AMERICAN FORK CITY PLANNING COMMISSION
AUGUST 4, 2021
REGULAR SESSION

AGENDA TOPIC: Hearing, review and action on the site plan for Roderick Catalyst Business Park, Phase I, located in the area of 1500 South 500 East, in the PI-1 Planned Industrial zone.

Planning Commission Meeting Date: 8/4/2021

RODERICK CATALYST-BUSINESS PARK BUILDING #3
454 EAST 1600 SOUTH, AMERICAN FORK, UT 84003
COVER SHEET

SITE PLAN

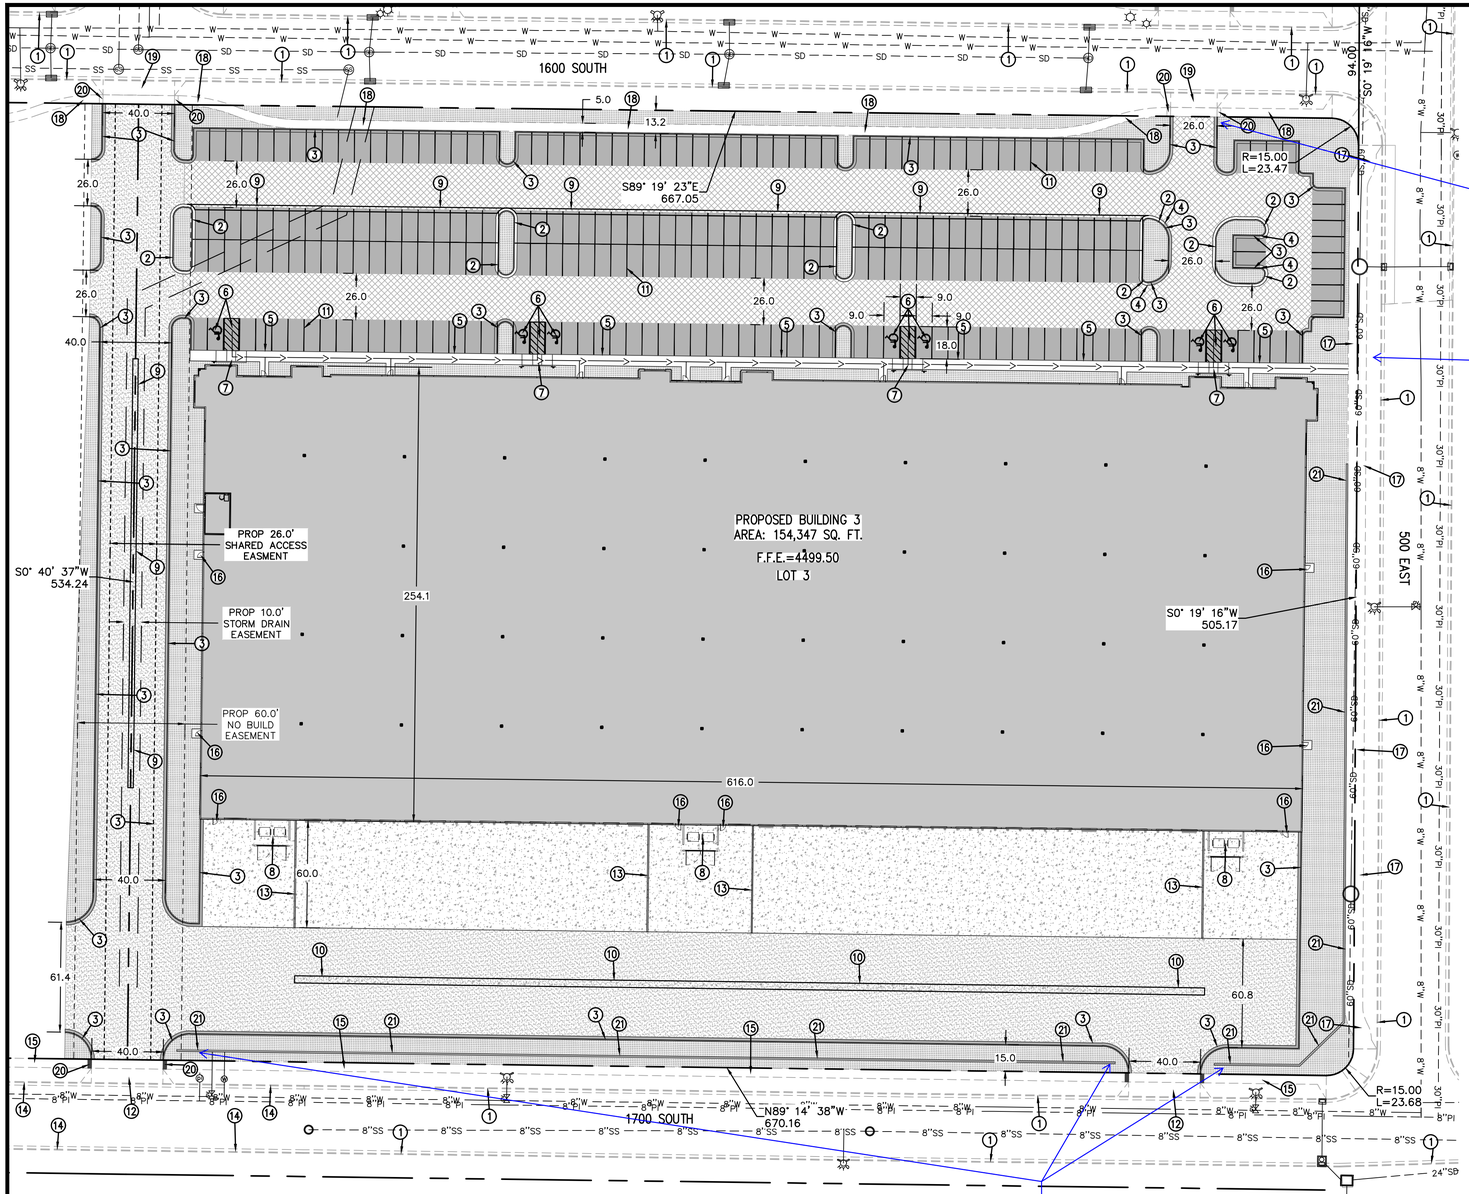
Show stop sign at all appropriate exits. (typ)

Show sight triangles 17.5.110

Show street trees spaced per city standards unless already shown with subdivision.

Show existing street lights from original subdivision plan. If original subdivision didn't install street lights, then show proposed street lights on this plan spaced according to city standards.

Verify that fence will not impose on sight triangles.

They would still be required to do those things. The only one that is a maybe is the stop signs at parking lot exits. I don't think our code specifically requires it, but I think your note to show at appropriate exits is a good note to include. All the other notes are good.

GRADING PLAN

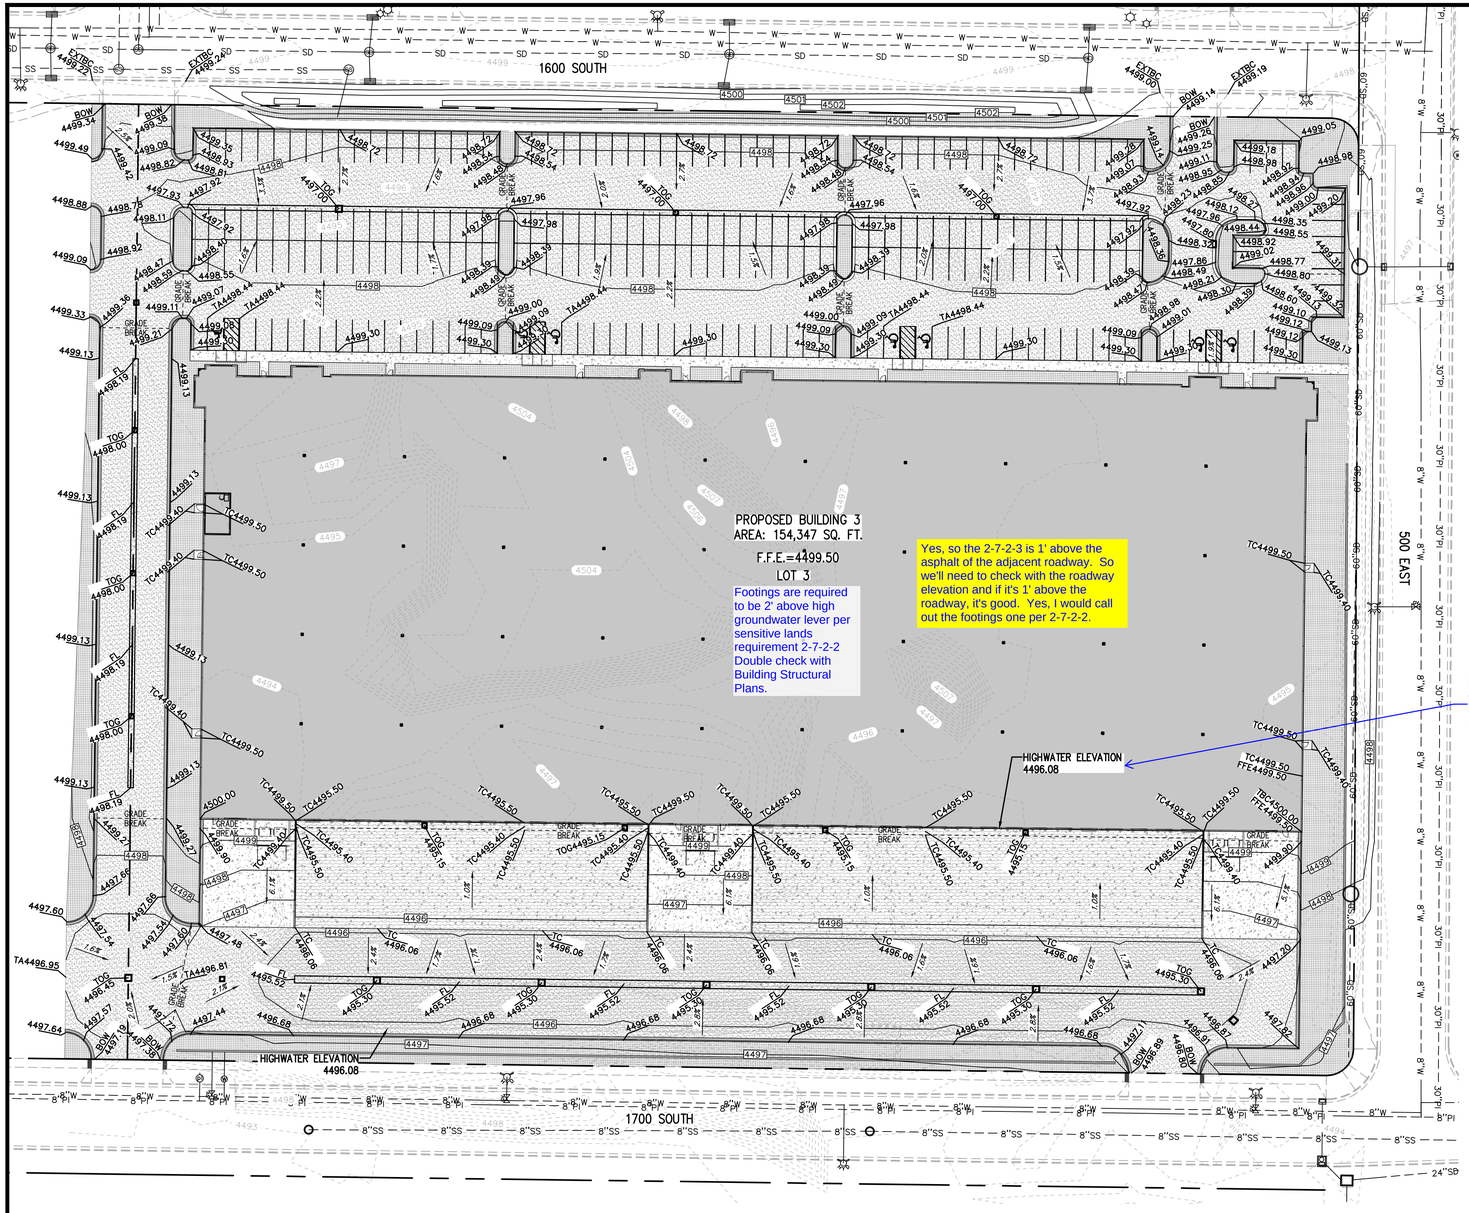
Footings are required to be 2' above high groundwater lever per sensitive lands requirement 2-7-2-2 Double check with Building Structural Plans.

DRAINAGE PLAN

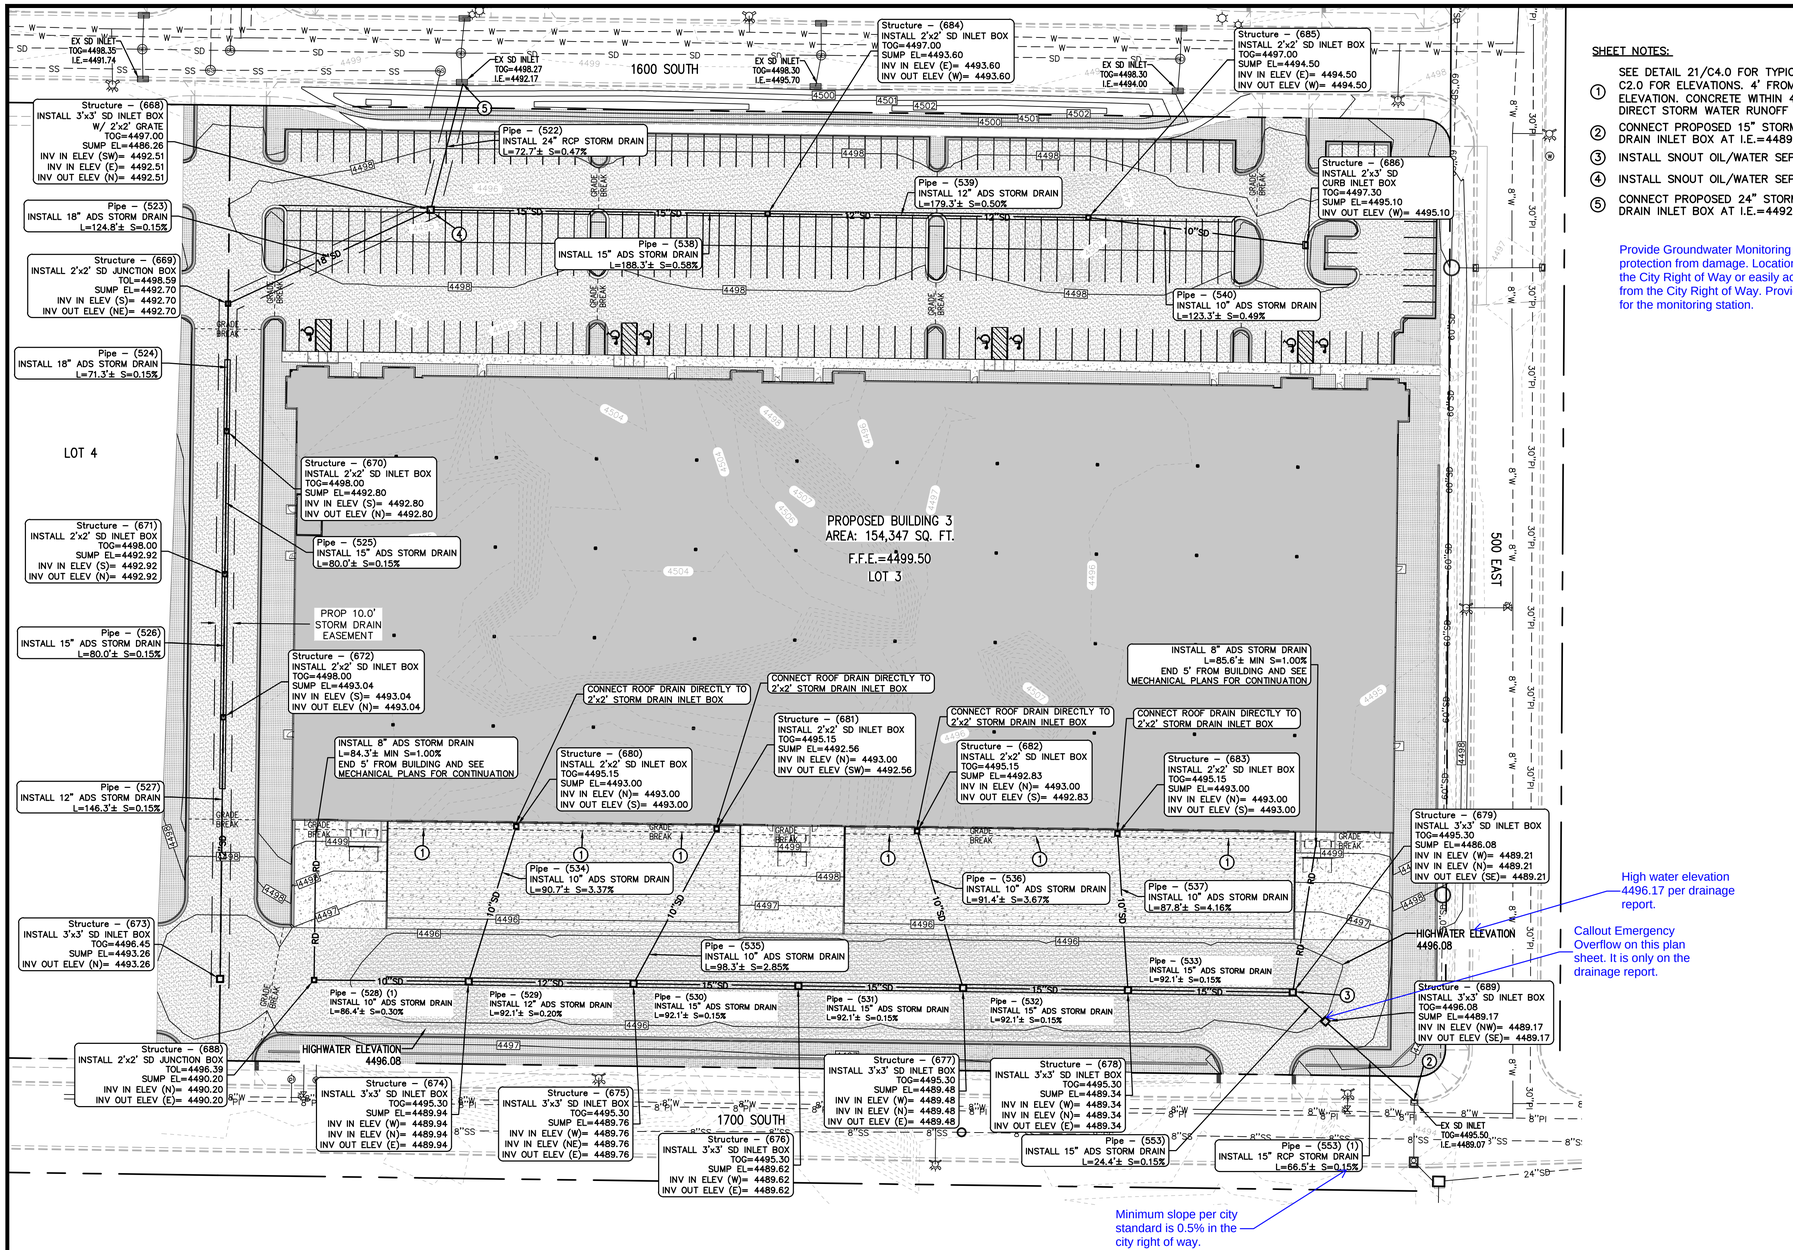
Provide Groundwater Monitoring Station with protection from damage. Location shall be in the City Right of Way or easily accessible from the City Right of Way. Provide a detail for the monitoring station.

UTILITY PLAN

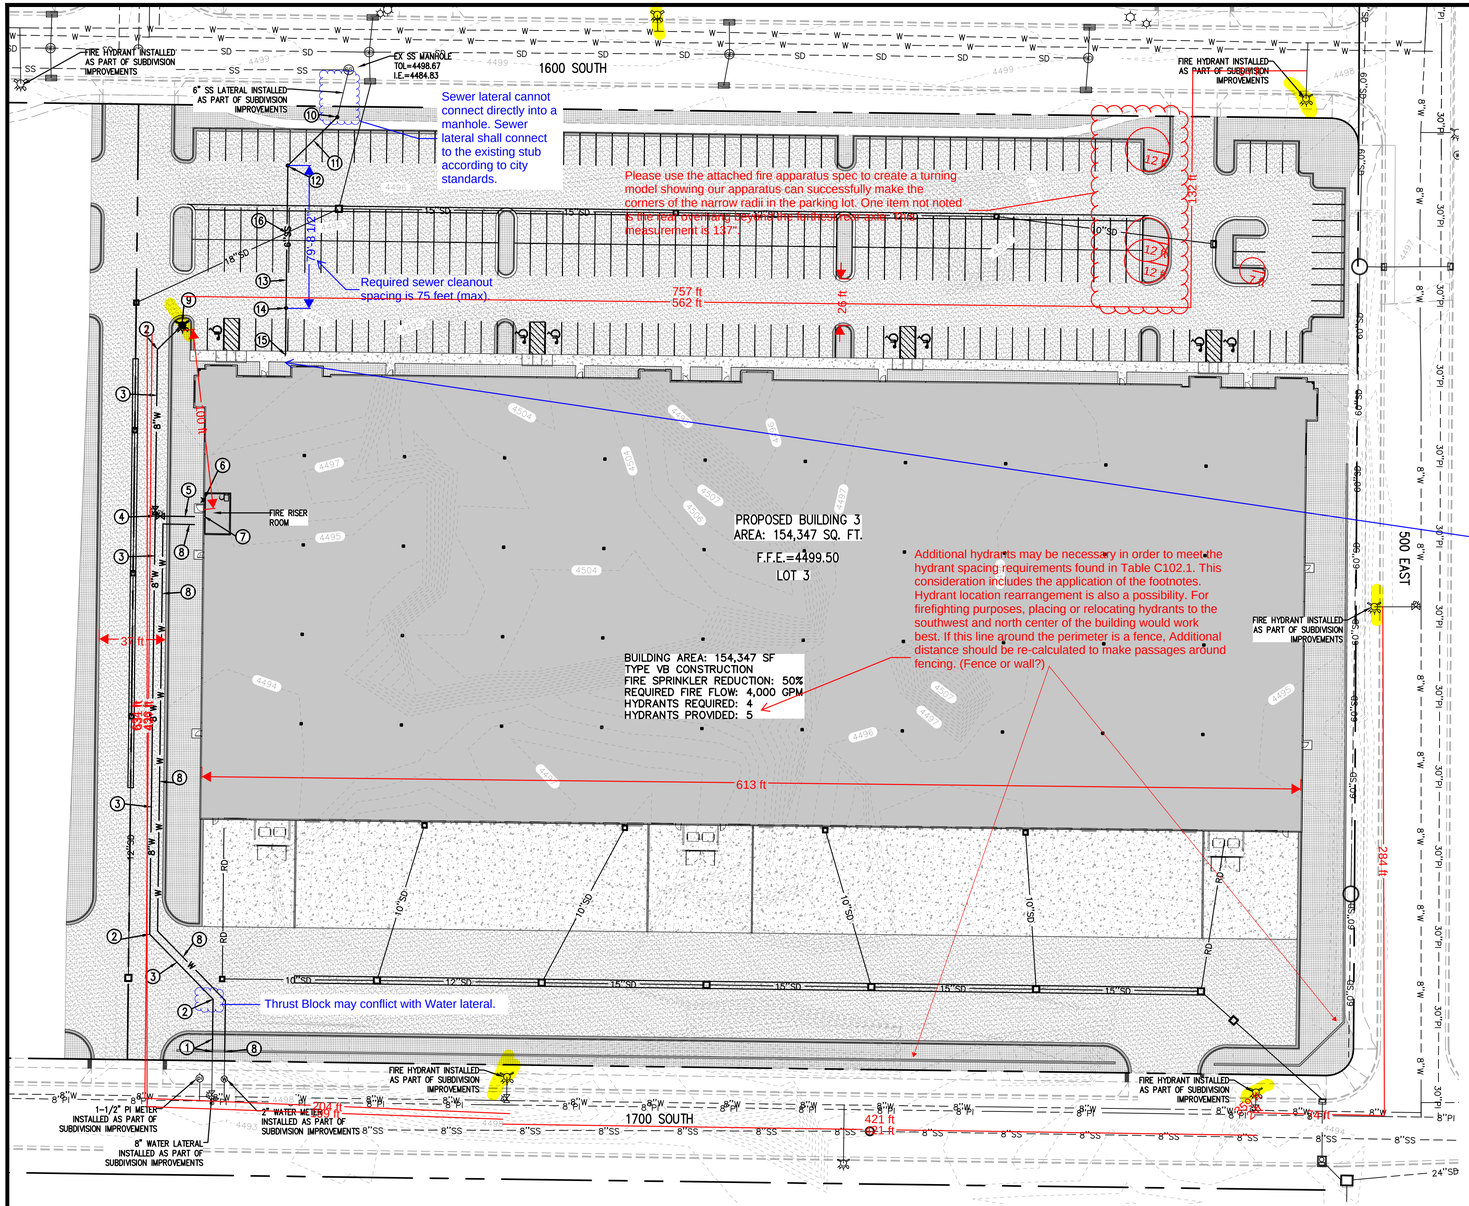
Sewer cleanout is required within 5' of the building foundation. Show here or specify that it is shown in the mechanical drawings.
